**PALOMAR ENERGY PROJECT (01-AFC-24)  
CEC STAFF DATA REQUEST NUMBER 106**

**Technical Area: Visual Resources**

**Response Date: April 8, 2002**

**FIGURE 106-1  
CUMULATIVE PROJECT LOCATIONS**

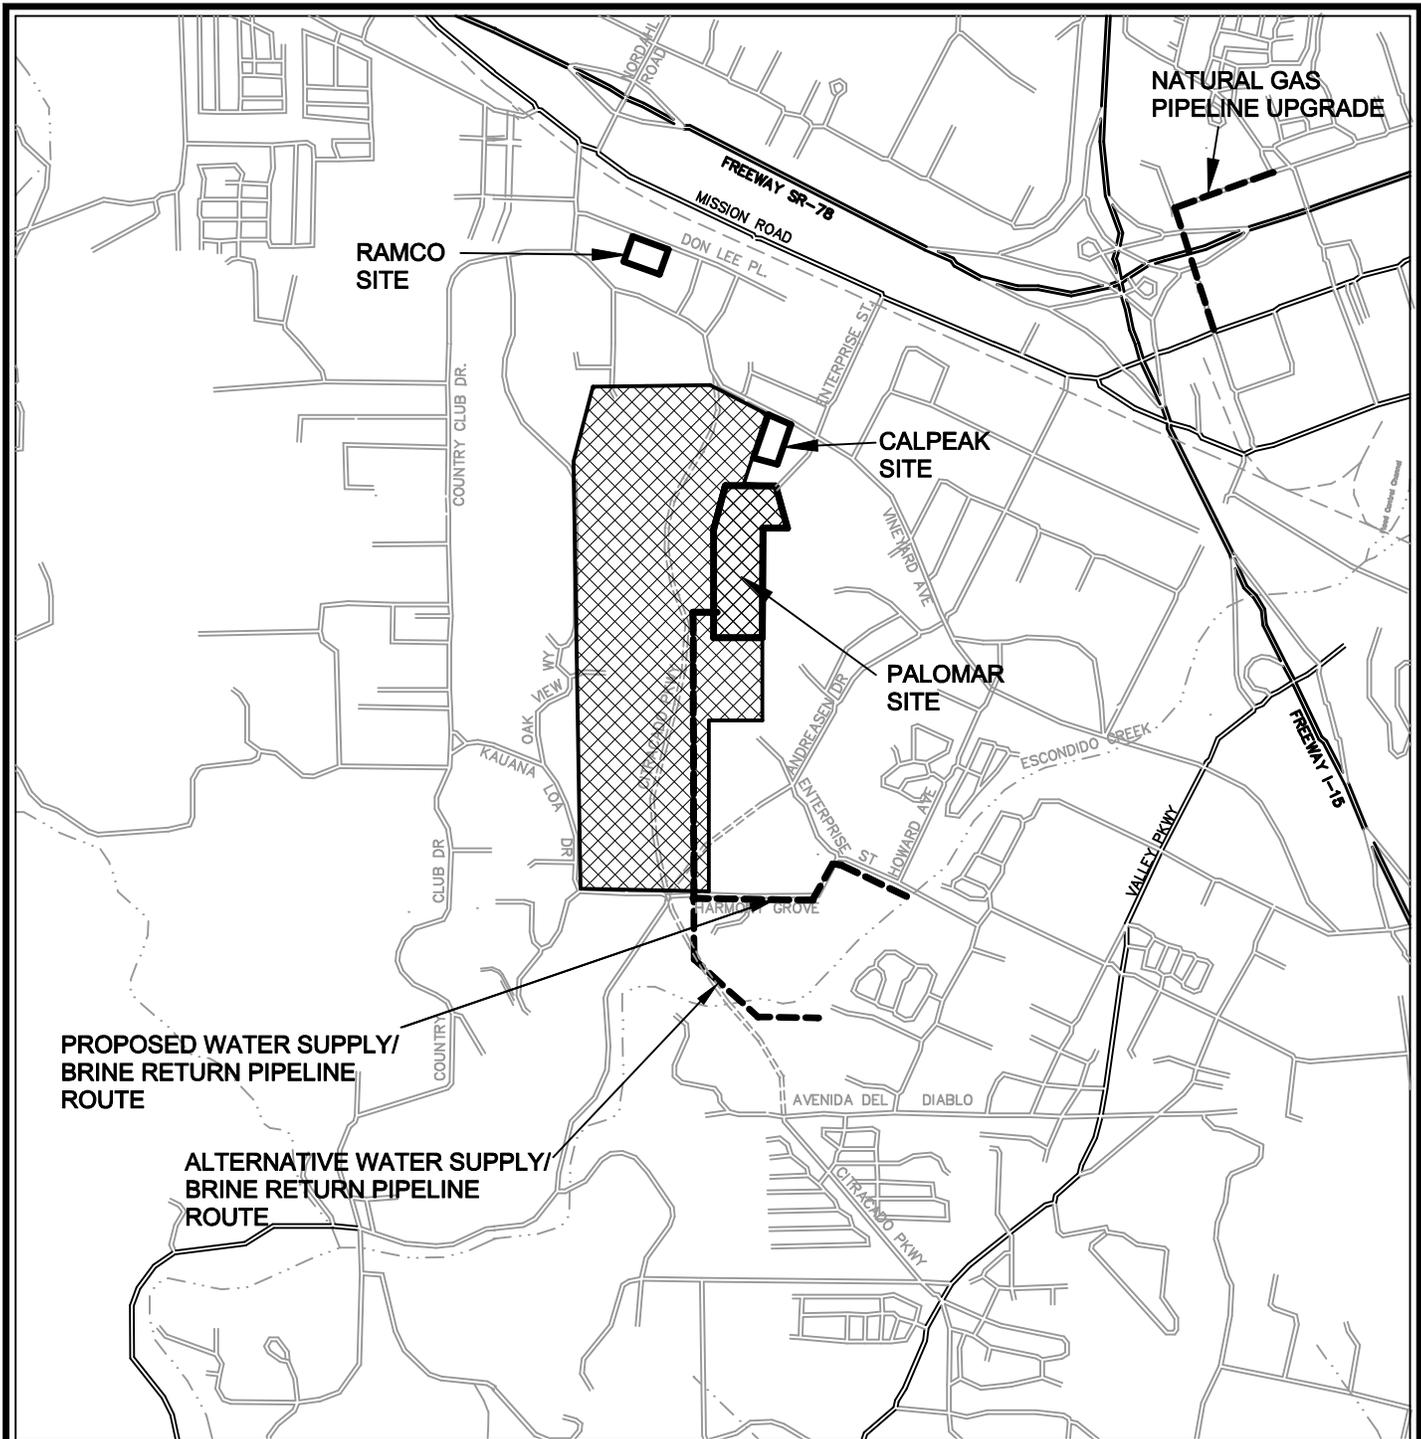
Please provide a map that shows the Proposed Project and the location of the two peaking power plants referenced in the Cumulative Impacts analysis on pages 5.10-23 and 24 of the AFC. Also include important street names on the map.

See Figure 106-1 for a map that shows the locations of the CalPeak and RAMCO facilities as well as the Palomar site.
